**TO:** Design Advisory Board  
**FROM:** Scott Gustin  
**DATE:** September 9, 2014  
**RE:** 15-0055CA, 15 Conger Avenue

**Request:** Construct second story addition to existing garage structure and convert to single family dwelling

SITE PLAN PROPOSED RESIDENCE 15-19 CONTRAIL AVE  
BURLINGTON, VT 05401  
DATE: 7.9.14 / 8.20.14  
SCALE: 1/4" = 1'-0"

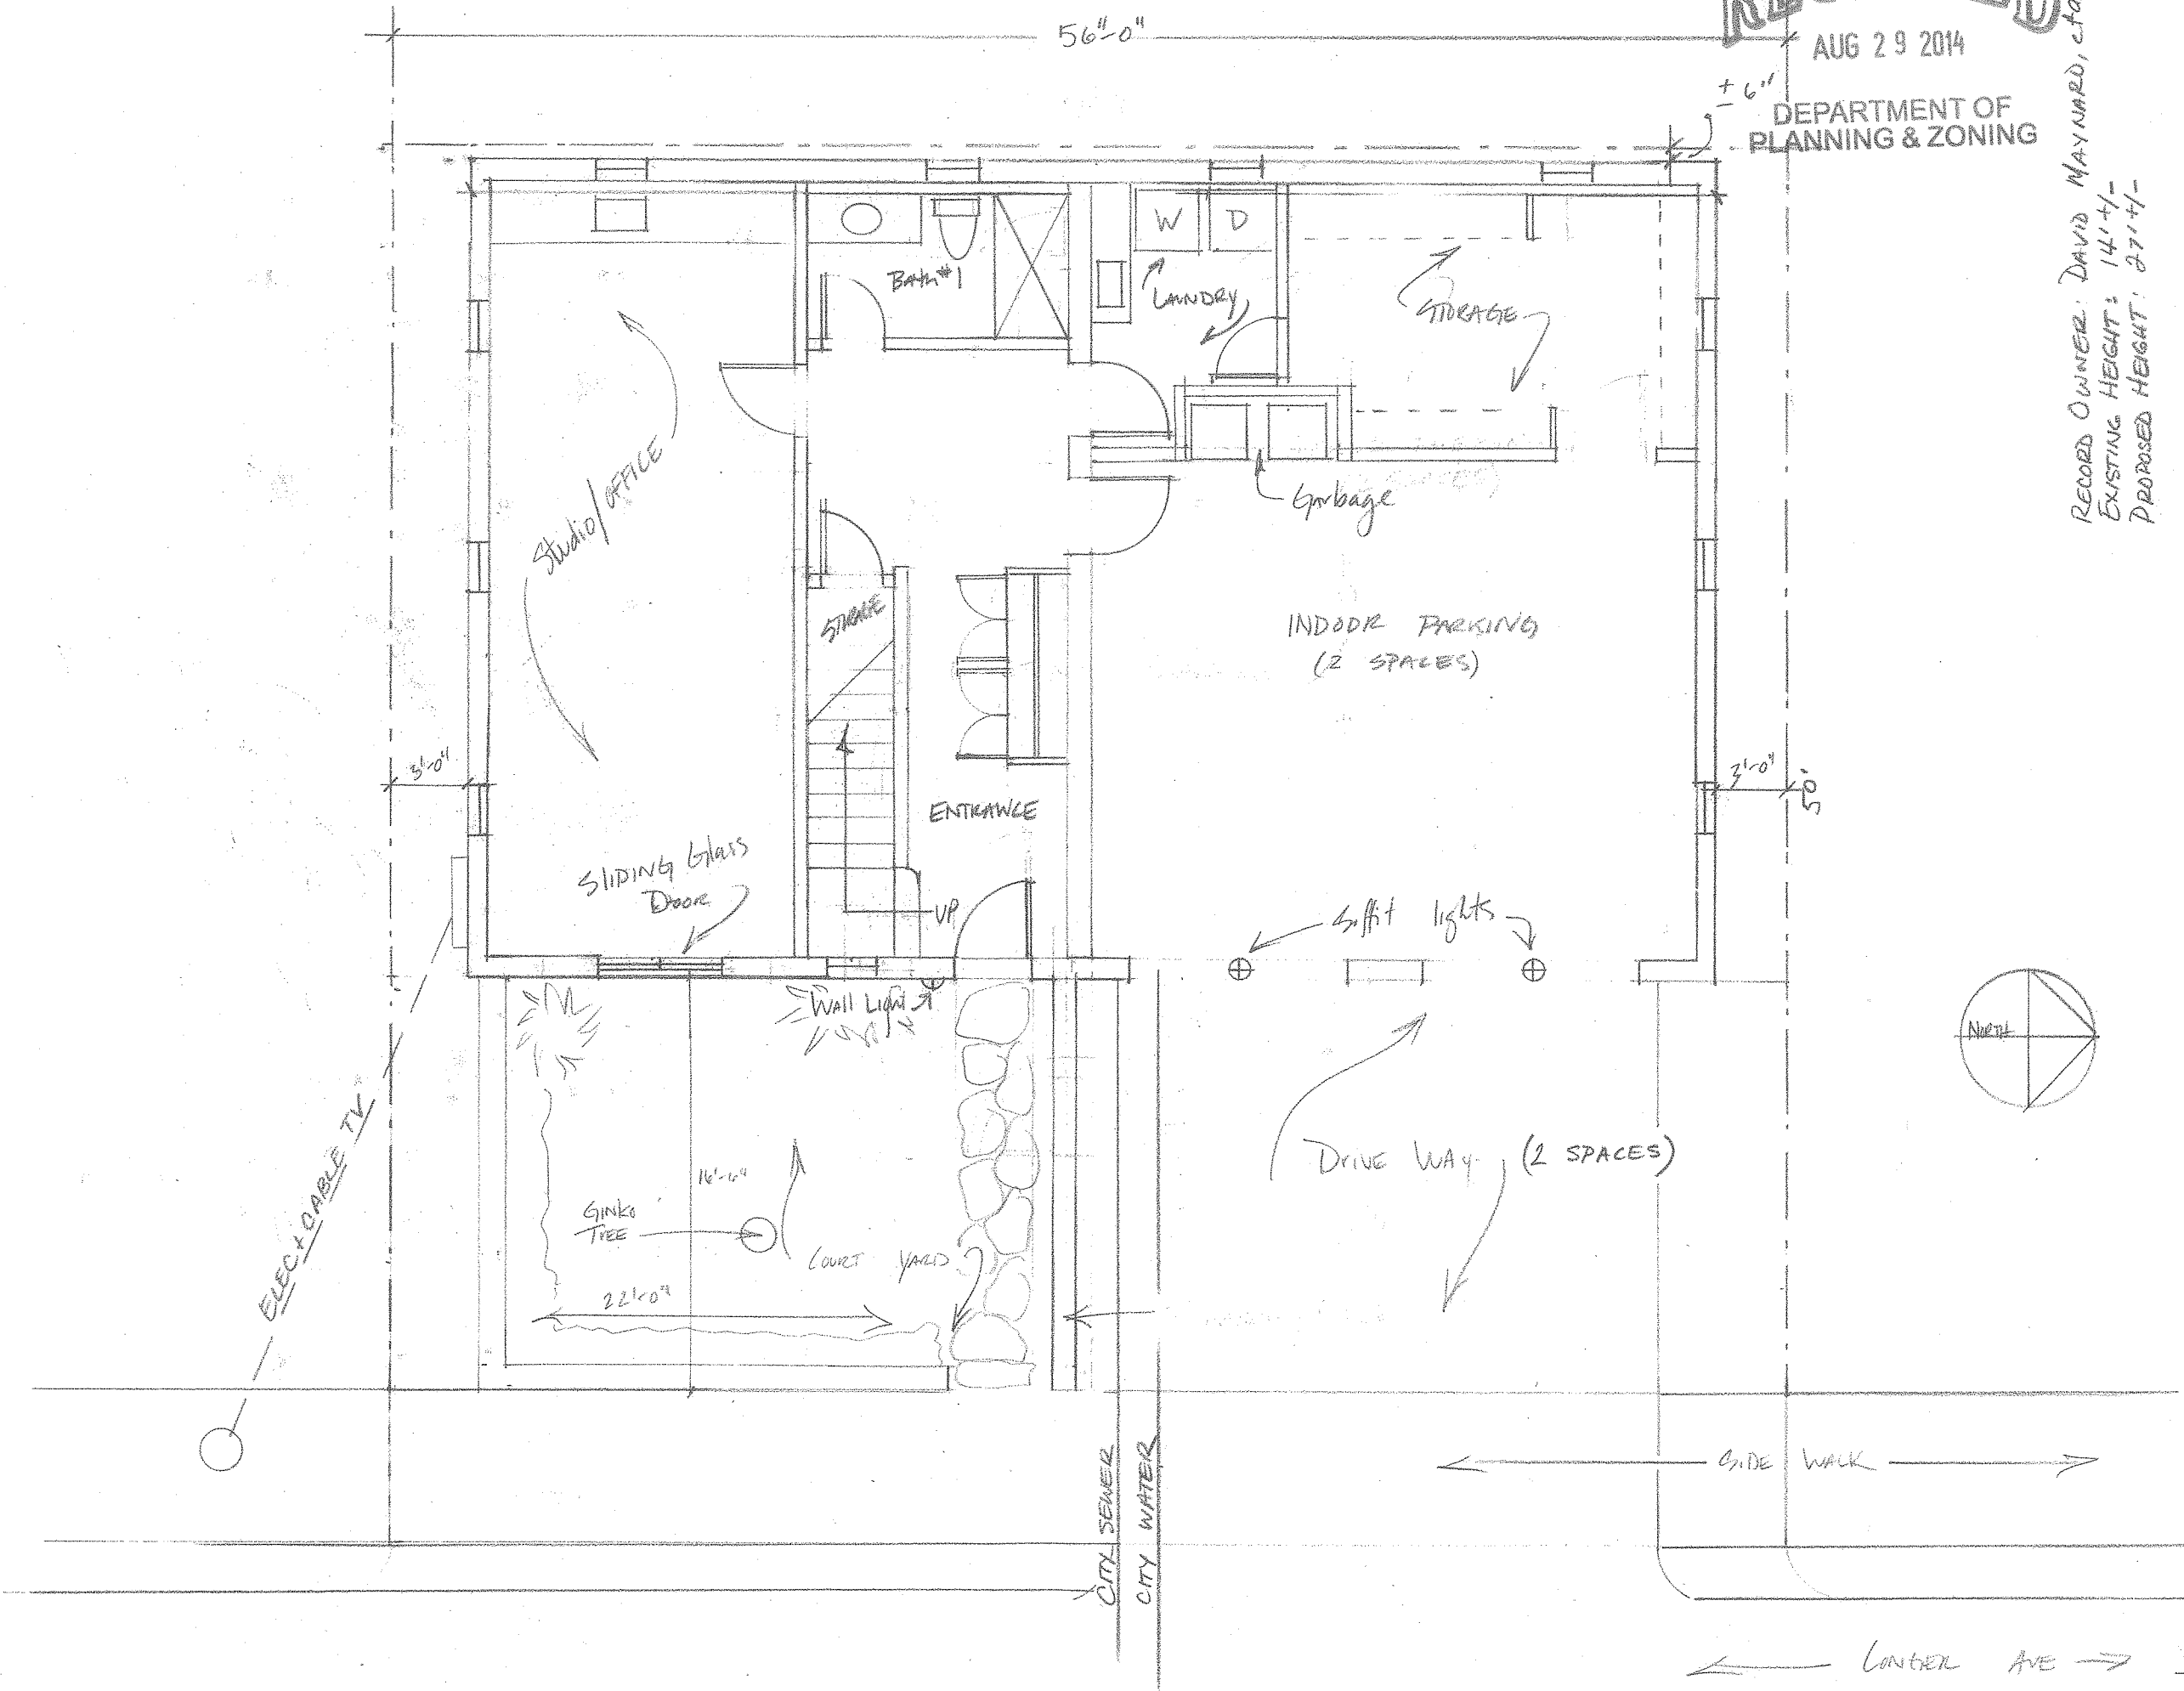
The garage presently contains four overhead doors facing Conger Avenue. Two of the four will be retained for access into the 2-bay garage. A single driveway will lead to these two garage doors. The driveway is 20' wide and exceeds the 18' maximum width. It must be narrowed accordingly (it may flare up to 20' by the garage entries). Driveway materials are undefined and must be noted. The driveway should be paved.

The revised plans contain minimal landscaping details and note only that a gingko tree will be planted in the front yard. The plans continue to refer to a "courtyard" in front. What the courtyard consists of is unclear. Grassy or garden area would be acceptable. Lot coverage constraints would prohibit any sort of hardscape material. Details as to what the courtyard will be are needed.

The previously proposed 7' tall masonry "fence" has been deleted in favor of a 3' tall wooden fence. Note that the plans refer to a wooden or masonry fence. Consistency with the application narrative requires that the plans be revised to indicate just a wooden fence. The newly proposed fence is much more appropriate to this neighborhood context and complies with the clear sight triangle for the driveway/street intersection.

Revised project plans now depict outdoor lighting fixture locations. They will illuminate the pedestrian and garage entries into the building. Note that locations noted on the site plans are

inconsistent with locations noted on the building elevation drawings. This inconsistency must be fixed. Fixture cut sheets have not yet been provided and need to be.

Any new utility lines must be buried. The site plan depicts a utility meter on the south side of the building. The south building elevation does not depict the utility meter. The utility meter must be depicted and screened. See also Sec. 6.3.2 (h) below.

1. Building location and orientation. Original 7 foot tall masonry wall has been deleted and, instead, a 36 inch wooden fence is proposed to enclose the front yard area. The front door to the building is now visible from the street and will be accessible directly via a sidewalk from the city sidewalk.
2. Vehicular access. Proposal is to delete two of the existing for driveway areas located in front of the garage building. Two of the "bays" will be converted to a new front yard area (see above). The other two bays will be maintained as driveways to access the remaining garage area.

3. Pedestrian access. A sidewalk is now shown connecting the public sidewalk to the building's primary entrance.
4. Landscaping and fences. A 3 foot tall fence is now shown in lieu of the original proposed masonry wall.

5. Outdoor lighting. Fixture locations are now shown on the building elevations and plans.
6. Integrate infrastructure into the design. All utility supply will be made underground. The electric utility meters located on the south side of the building will be screened from the road/sidewalk with a cedar shrub.
7. Building openings. Window drawings are now provided in more detail.
8. Quality of materials. Material types and locations are now specified on the plans.
9. Reduce energy utilization. All construction will meet current energy efficiency requirements and regulations. For example, we propose to use insulated concrete filled foam blocks ("ICFs") to construct the first floor structure. This technique will allow enhanced energy efficiency in addition to providing necessary fire protection.

NORTH / SOUTH ELEVATIONS, PROPOSED RESIDENCE 15117 CENTER AVE  
DATE: 7.10.14 / 8.28.14  
SCALE: 1/4" = 1'-0"

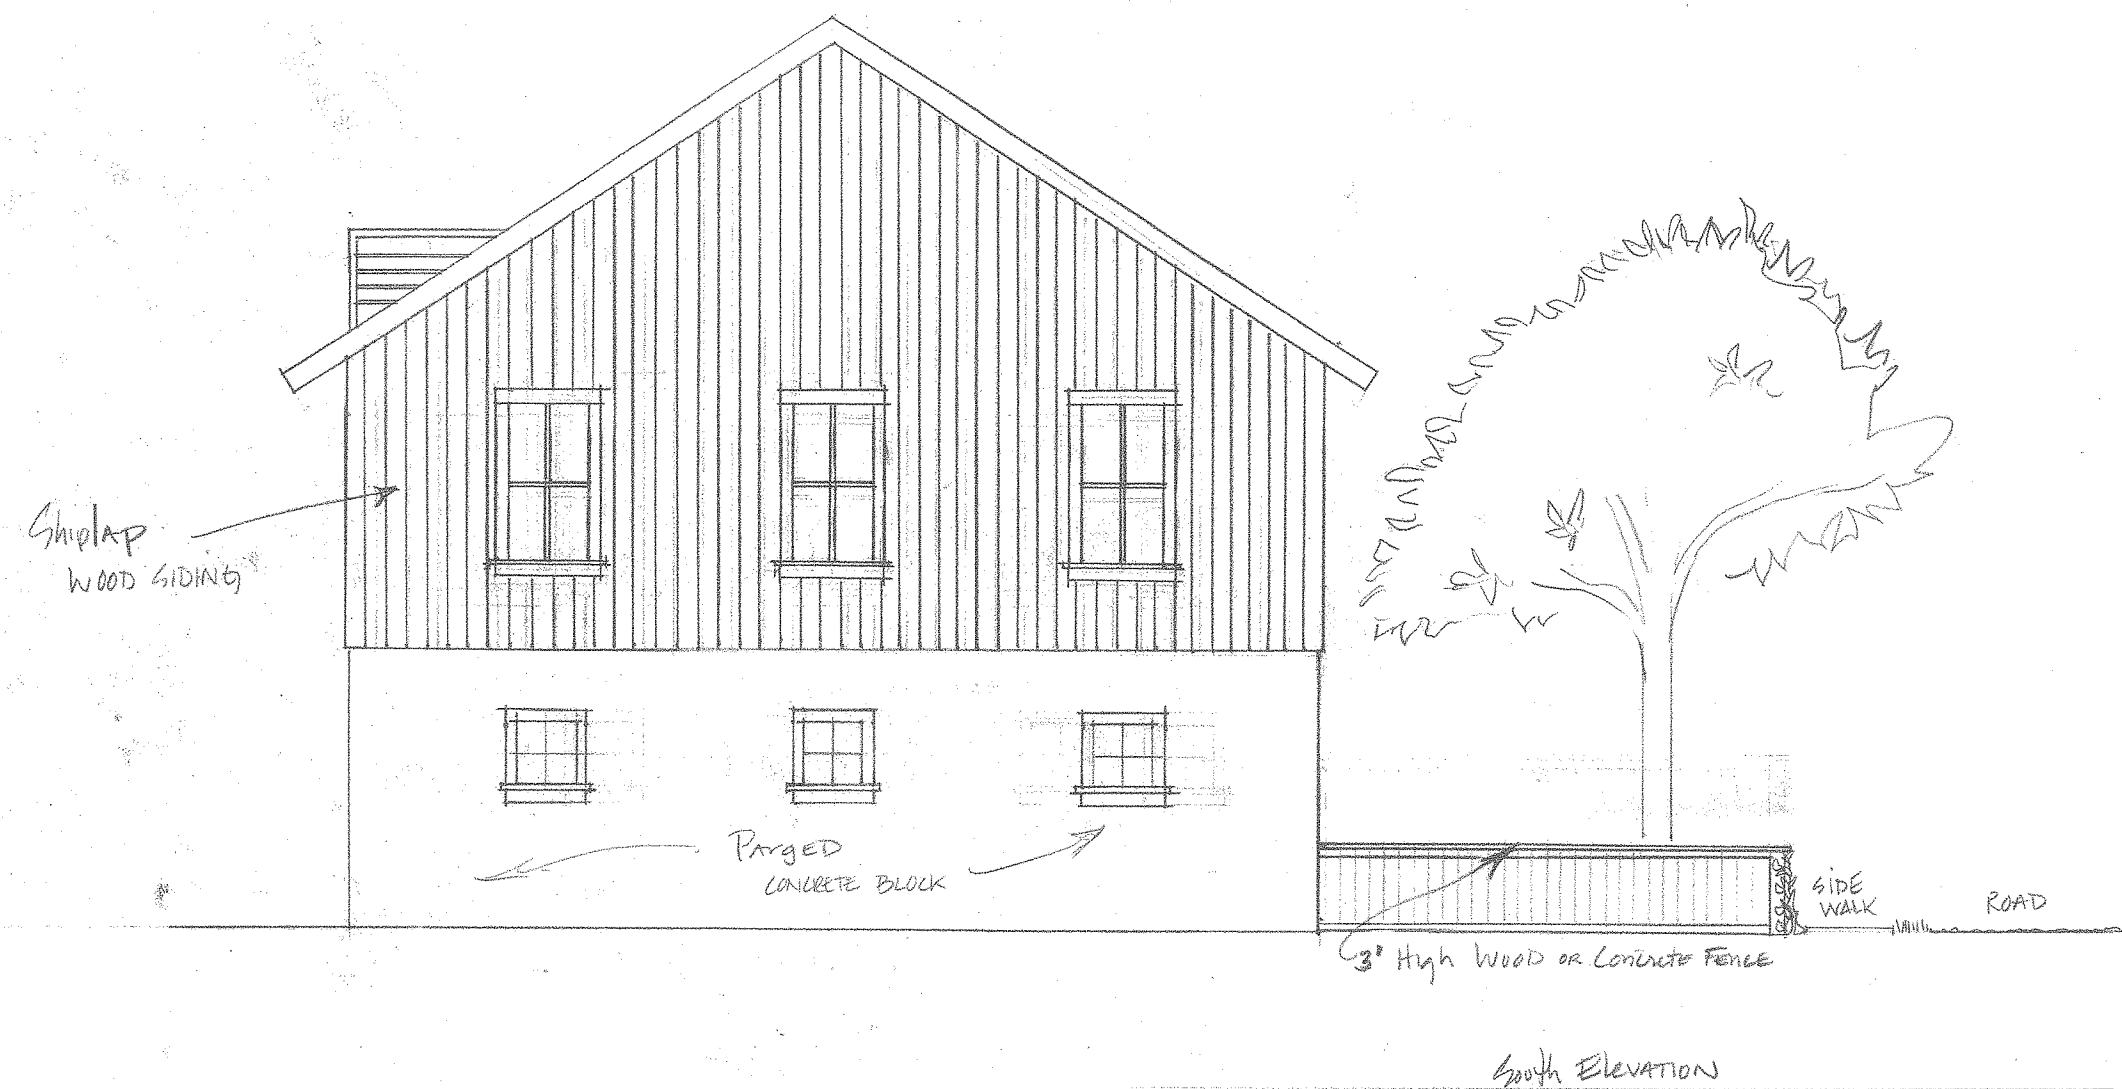
As noted above, utility meters will be located on the side of the building. They must be noted on the building elevation drawing and screened. No exterior mechanical equipment is included in the project plans. If any is proposed, it must be depicted and screened. Trash should be stored inside the garage until curb side pick-up days.
